Assessment of Dam Safety Coal Combustion Surface Impoundments (Task 3) Final Report

American Electric Power
Cardinal Power Plant
Brilliant, Ohio

December 9, 2009

CHA Project No. 20085.1080.1510

<small>Drawing Copyright © 2007 CHA</small>	STABILITY ANALYSIS BOTTOM ASH COMPLEX CARDINAL STEAM PLANT BRILLIANT, OHIO	PROJECT NO. 20085.1080
		DATE: SEPT 2009
		FIGURE 9A

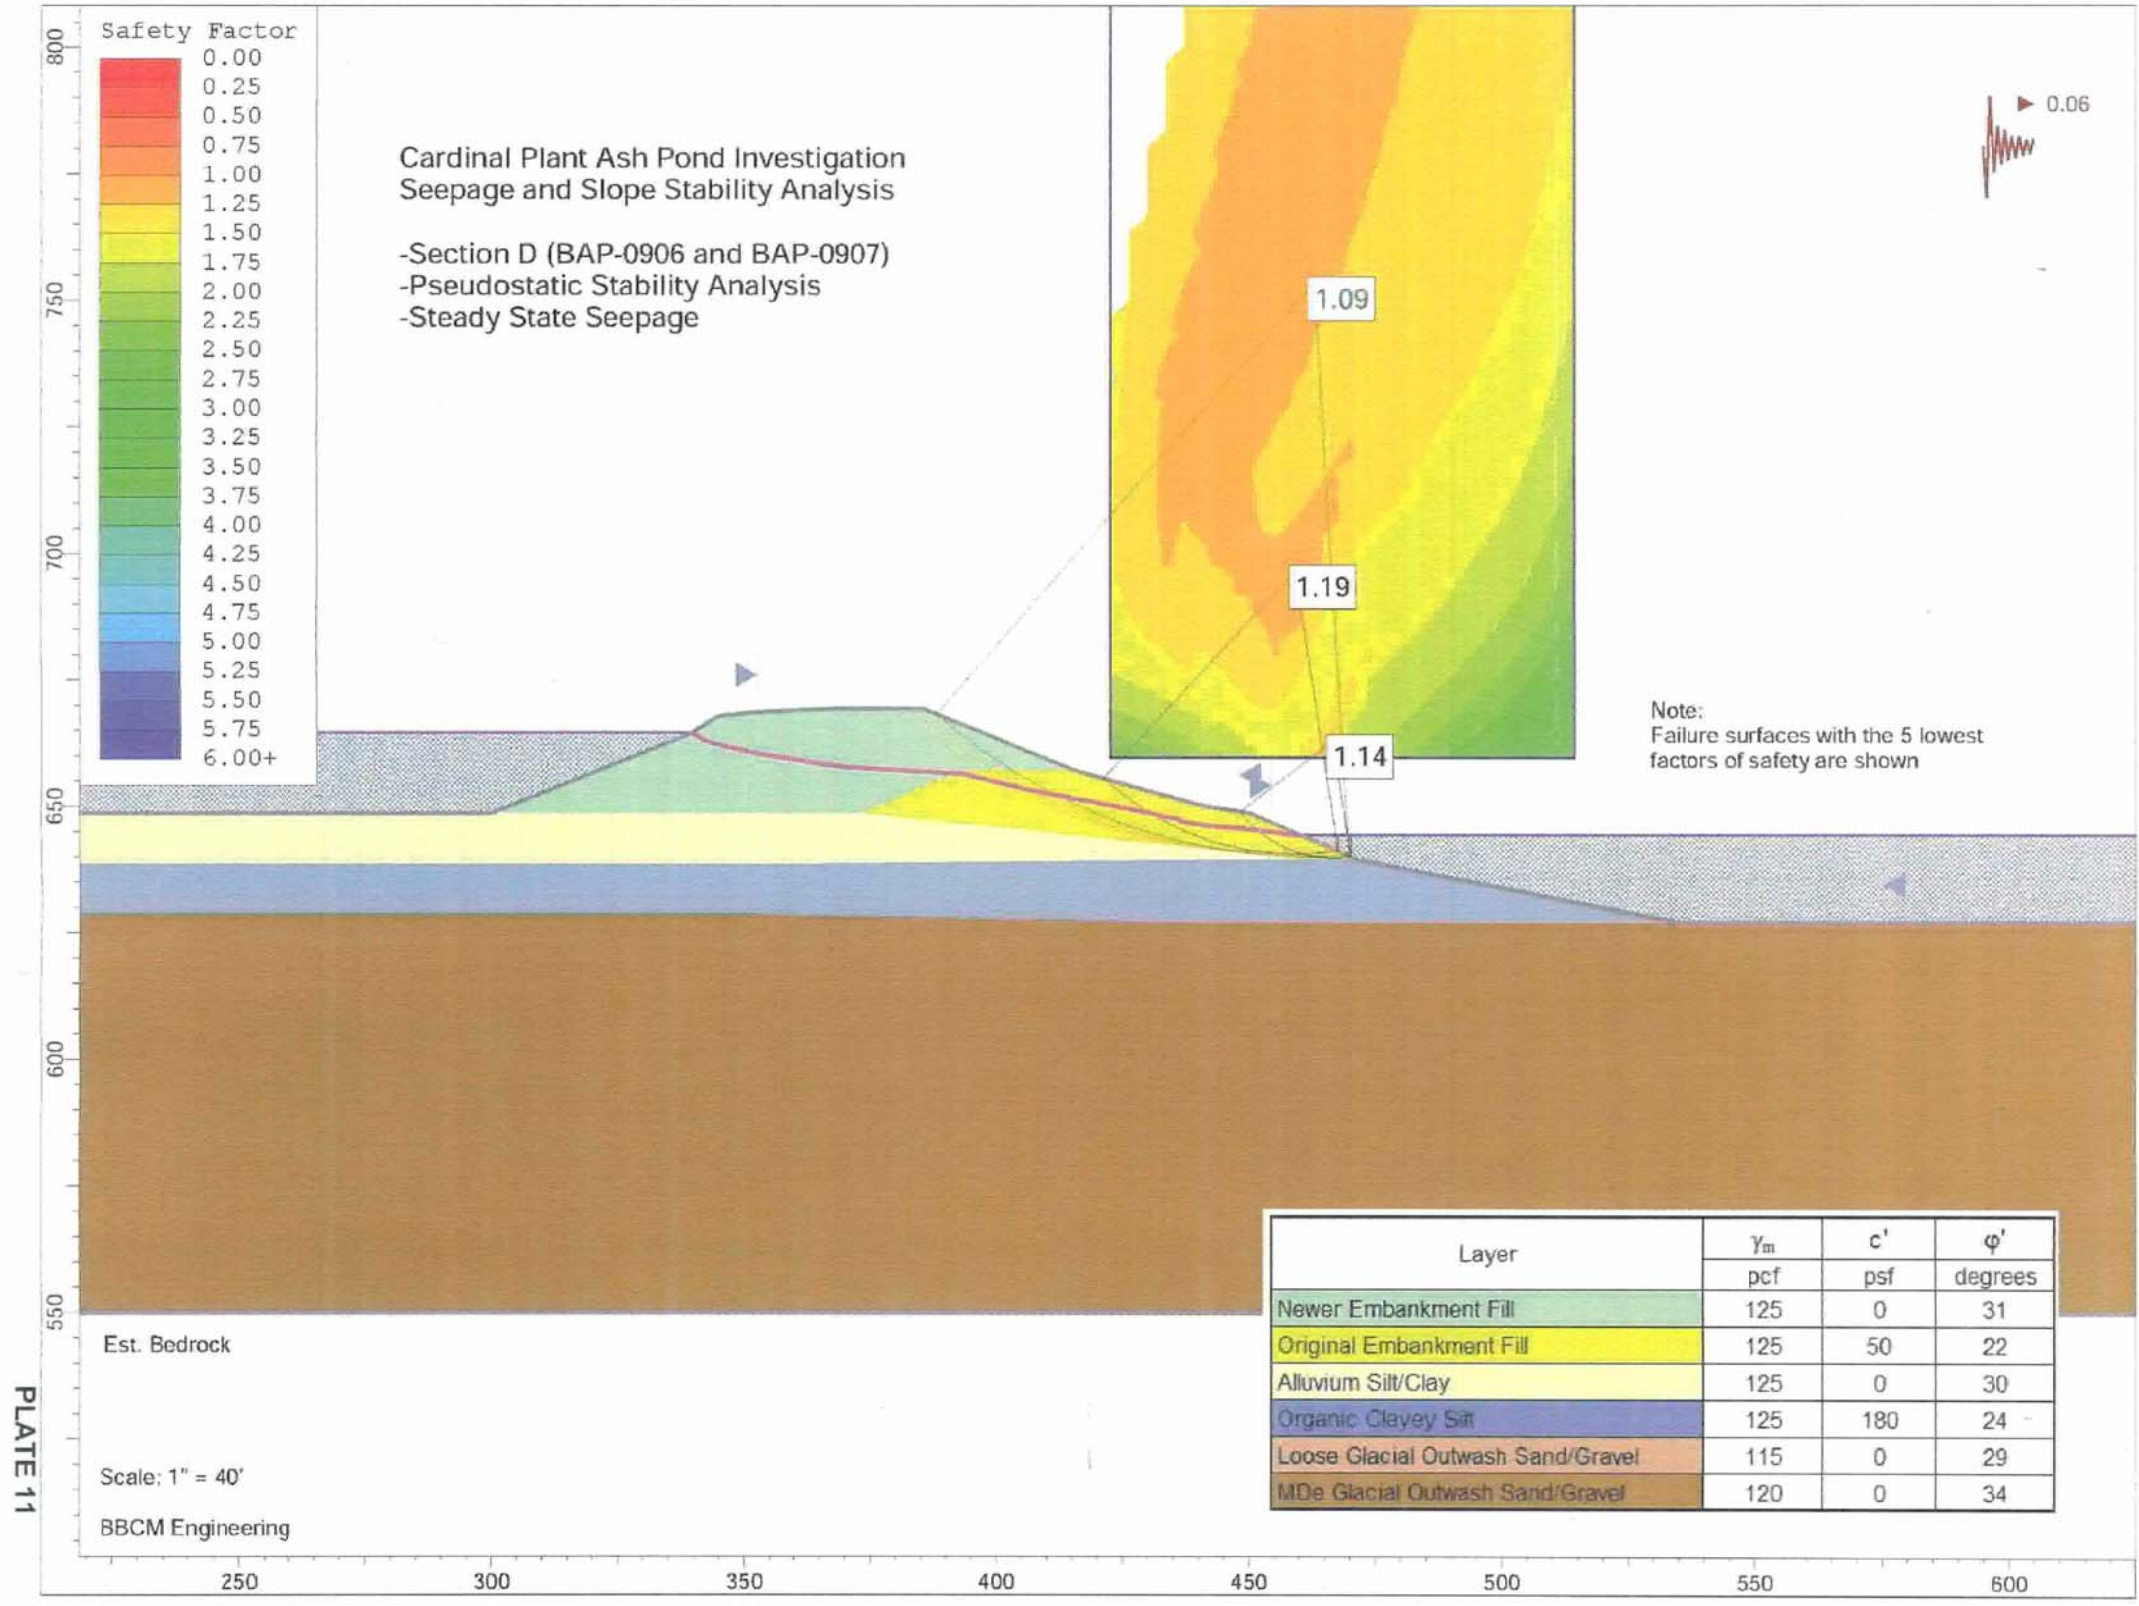
Load Case	Required Minimum Factor of Safety	Calculated Minimum Factor of Safety	
		Section B	Section D
Steady State Conditions at Present Pool Elevation (Downstream Slope) (See Figure 9A – Section D)	1.5	1.57	1.52
Rapid Draw-Down Conditions from Present Pool Elevation	1.3	Not Performed as Part of the BBCM Evaluation	
Maximum Surcharge Pool (Flood) Condition	1.4	Not Performed as Part of the BBCM Evaluation	
Seismic Conditions at Present Pool Elevation (Downstream Slope) (See Figure 9B – Section D)	1.0	1.4	1.2
Liquefaction	1.3	Not Performed as Part of the BBCM Evaluation

EXAMPLE OF PIEZOMETER DATA CARDINAL STEAM PLANT BRILLIANT, OHIO	PROJECT NO. 20085.1080
		DATE: SEPT 2009
		FIGURE 10

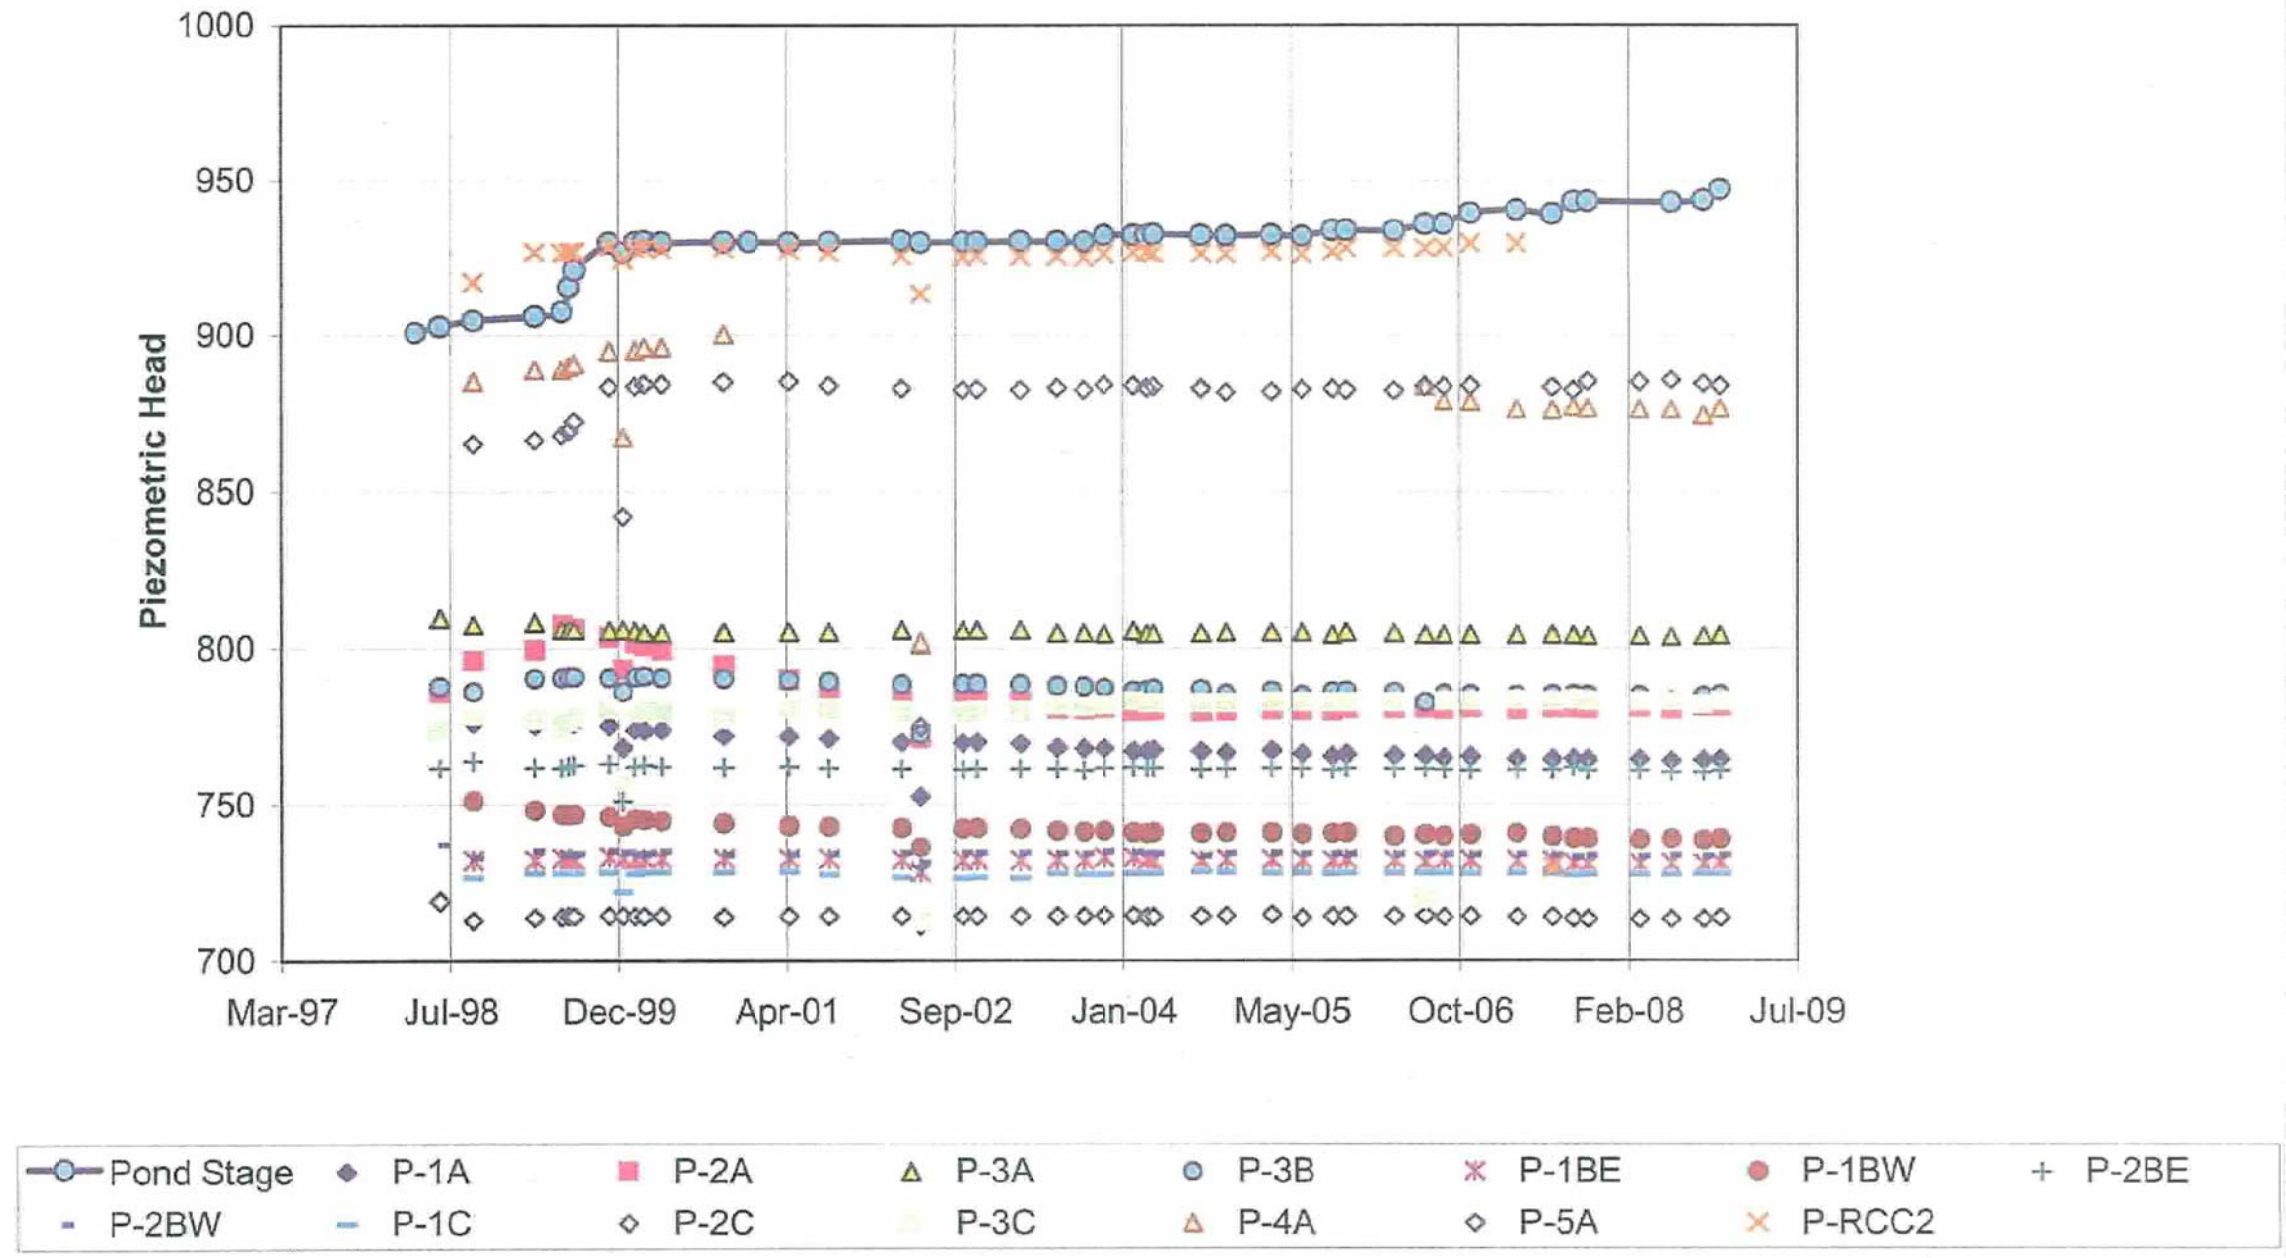
The stability analyses were performed for the maximum storage pool at elevation 960 and the maximum surcharge pool at elevation 968. The current pool elevation is about 13 feet below the design maximum. CHA reviewed piezometer data (Figure 10) provided by AEP and compared the phreatic surface in the dam to the pool level, downstream profile, and approximate design elevation of the chimney and blanket drain and concluded that the drain is working as intended, pulling the phreatic surface down to the design levels.

CUMULATIVE SETTLEMENT CARDINAL STEAM PLANT BRILLIANT, OHIO	PROJECT NO. 20085.1080
		DATE: SEPT 2009
		FIGURE 11

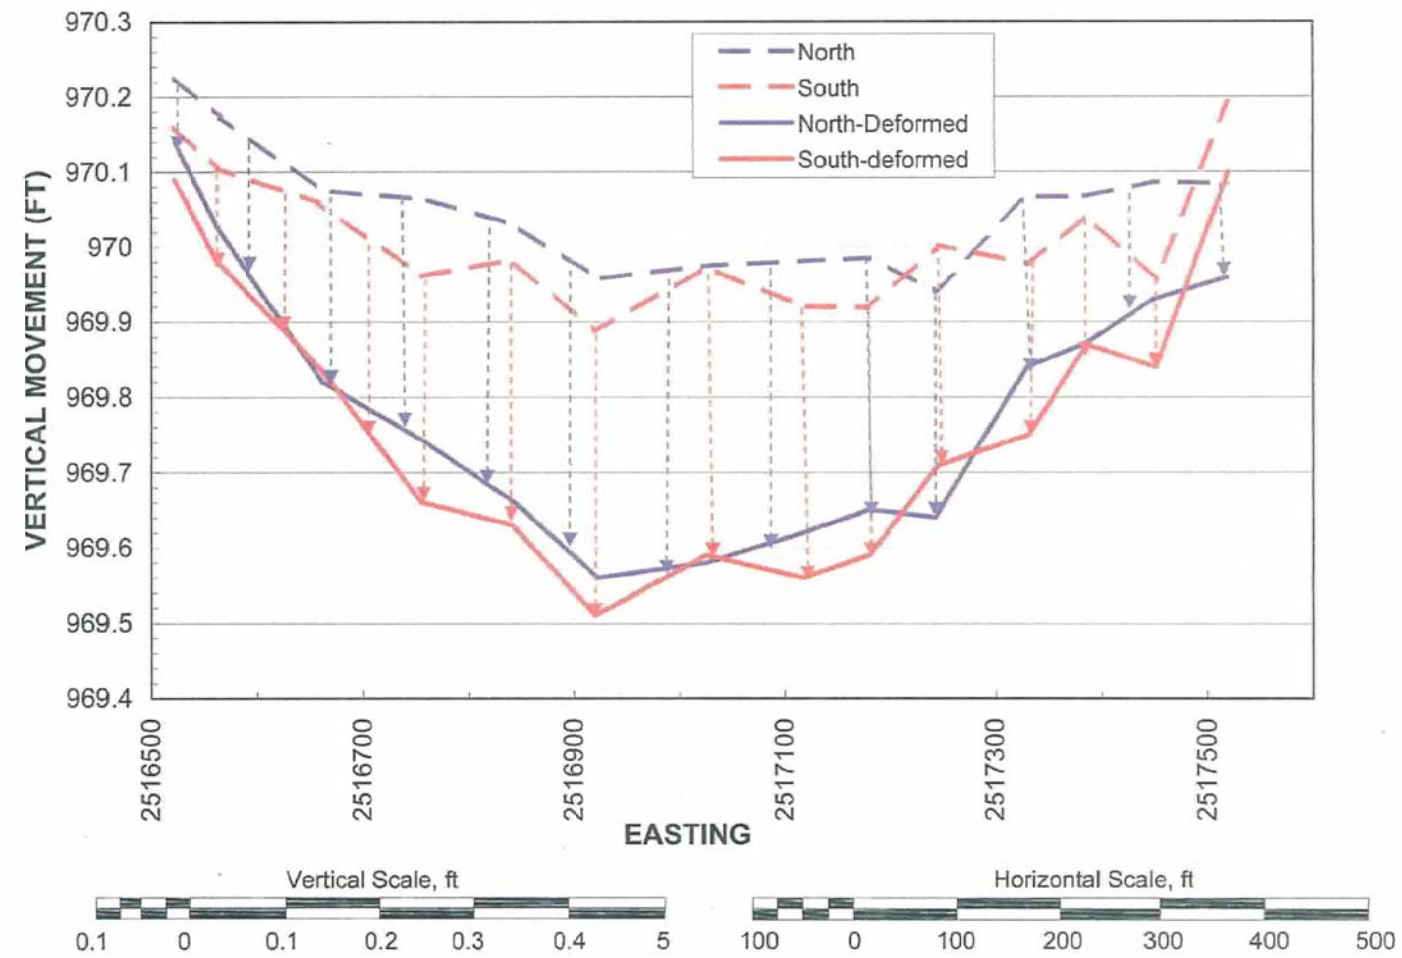
Settlement monitoring points along the crest and downstream slope have shown settlements ranging between from approximately 2.5 to 6 inches since the RCC crest was completed in 1999 (Figure 11). Slope inclinometer data indicates smaller cumulative lateral deformations on the order of 0.5 to 0.8 inches or less over the same time period. These measurements are consistent with the design stability of the dam. AEP should continue to be vigilant in monitoring the instrumentation at this facility as a way of evaluating the performance of the dam.
